218316

## **RESPONSE TO REQUEST FOR ADDITIONAL INFORMATION – TRAFFIC PEER REVIEW WESTMEAD CATHOLIC COMMUNITY SSD-10383**

**RE: WESTMEAD CATHOLIC COMMUNITY  
RESPONSE TO DEPARTMENT OF PLANNING LETTER DATED 24<sup>TH</sup> NOVEMBER 2020**

Figure 4: Future East-West Connectivity

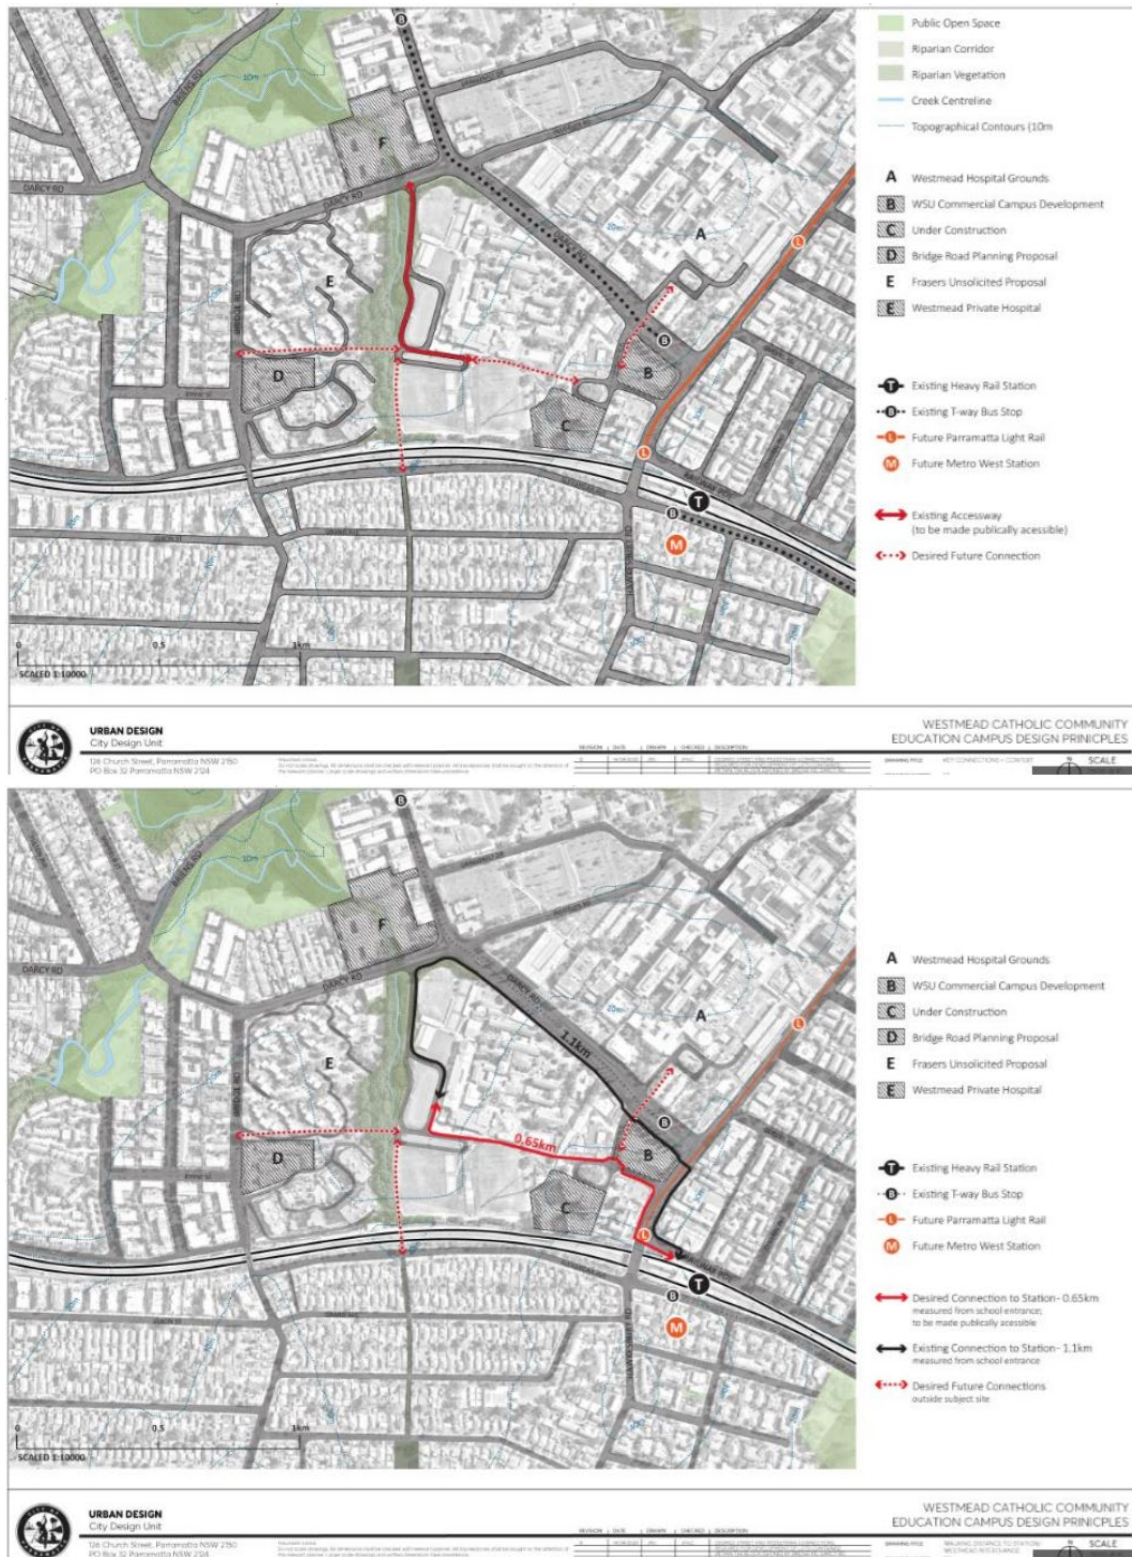
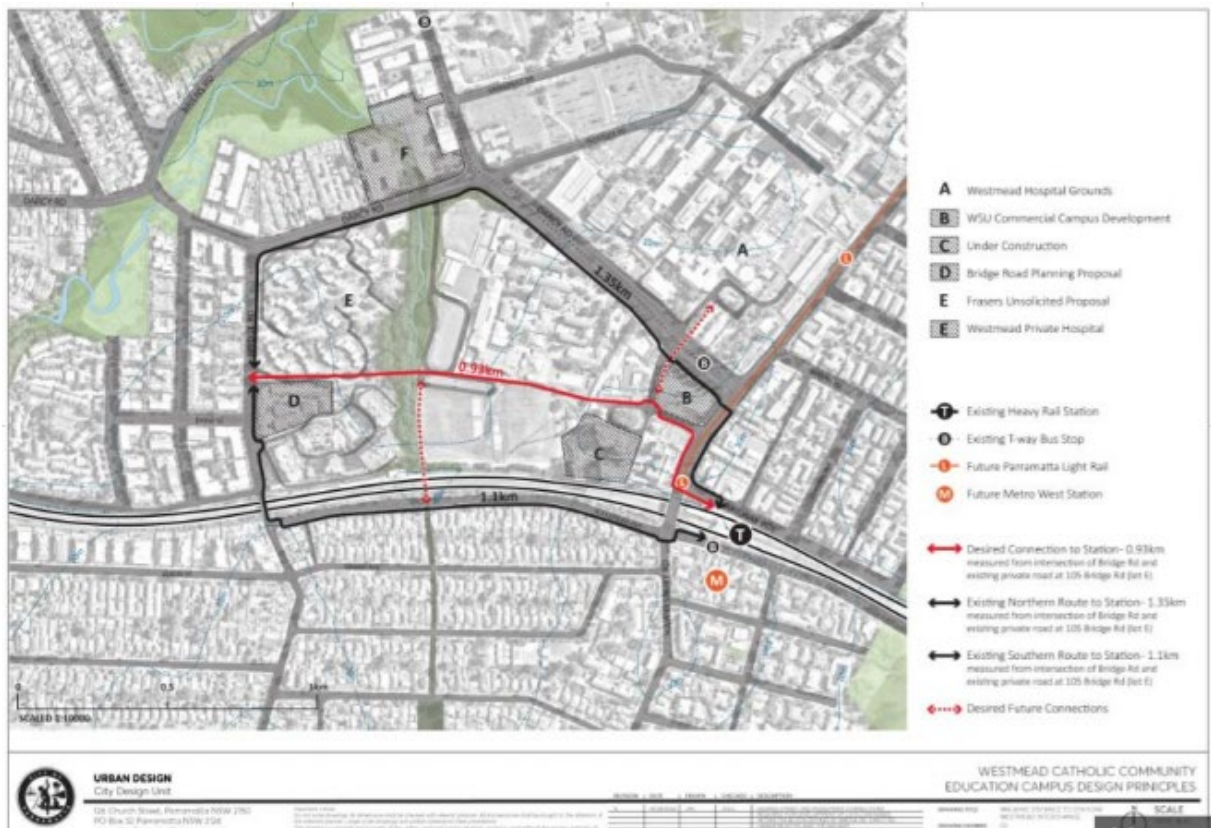
In the Response to Submissions phase, Council identified concerns about the future permeability of the subject site and the provision of new connections, mainly to the west. Council identified that the draft Westmead Innovation District Masterplan includes a link from the primary school car park direct to Bridge Road, as shown in Figure 4.

Notably, the link road between the subject site and Bridge Road has not been included in the Westmead 2036 Draft Place Strategy. Rather, the Strategy shows a north-south green link (pedestrian/ cyclist connection) across the rail line (refer to Figure 2).

As above, the Proponent would be willing to provide for a Bridge Road connection point within and up to their site boundary. Delivery of the road connection to Bridge Road itself would be through neighbouring sites, which would be dependent on other landowners/ developers to deliver this portion of the link. This messaging has been made clear to Council at several meetings during the Response to Submissions phase.

Aerial images of the pre-existing and current intersection layout at the subject intersection are illustrated below.

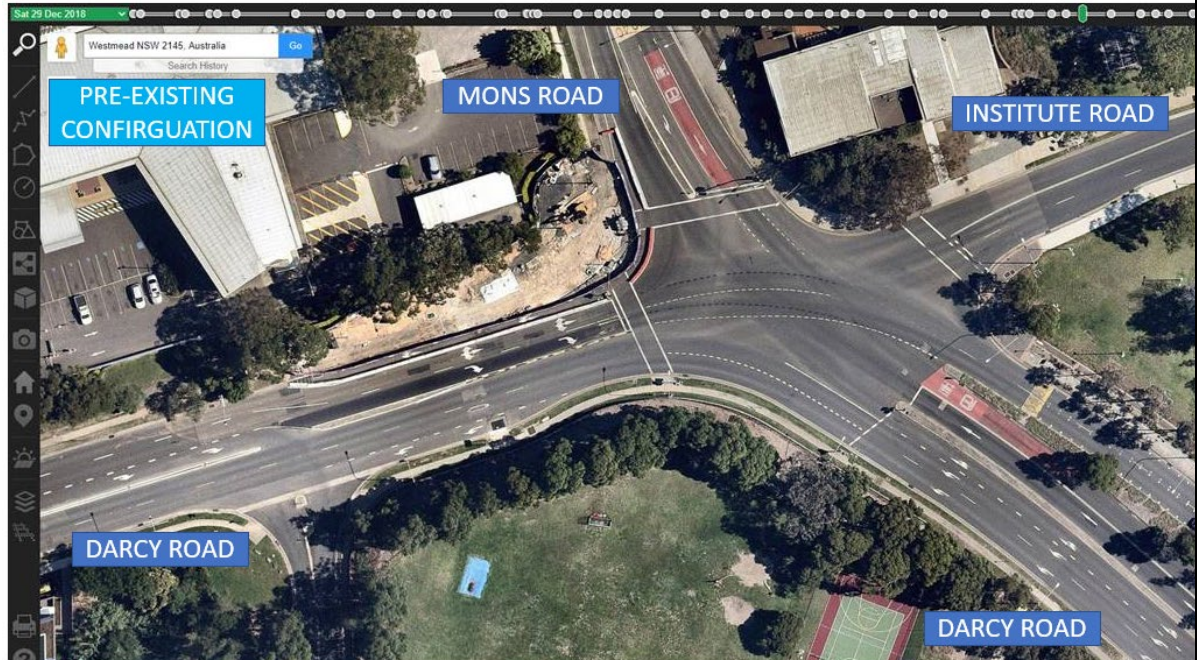
As an example, the Department notes that SIDRA modelling has applied co-ordination at signalised sites 8, 6, and 4 with 'offset' set as 0 second. However, the Department cannot verify the offset as no '.LX' file data is available. These should be provided so that the Department can verify the signal timings and calibrate or validate the SIDRA model.

| Item | Section/Page        | Bitzios Comments  | Bitzios Priority | Ethos Urban response and action (if any)  |
|------|---------------------|---|------------------|---|
| 42   | Signal Coordination | Co-ordination was applied at signalised sites 8, 6, and 4. However, with 'offset' set as 0 second. It was not possible to verify the offset as no '.LX' file data was available. However, it is highly unlikely that offsets are set as 0 seconds in this corridor.   | High             | The revised base case modelling addresses queries on the offset. Responses to the detailed findings following Bitzios' review of the SIDRA modelling are provided in Attachment A which cover this query.   |

In responding to DPIE's and Bitzios' queries, the base case configuration and signal phase timings have been reverted in accordance with the pre-existing intersection. Due to the reduced capacity at this junction under the pre-existing configuration, which presumably the new left-turn slip lane and other upgrades were implemented to overcome, the intersection operates at a reduced level of service in the revised base case.
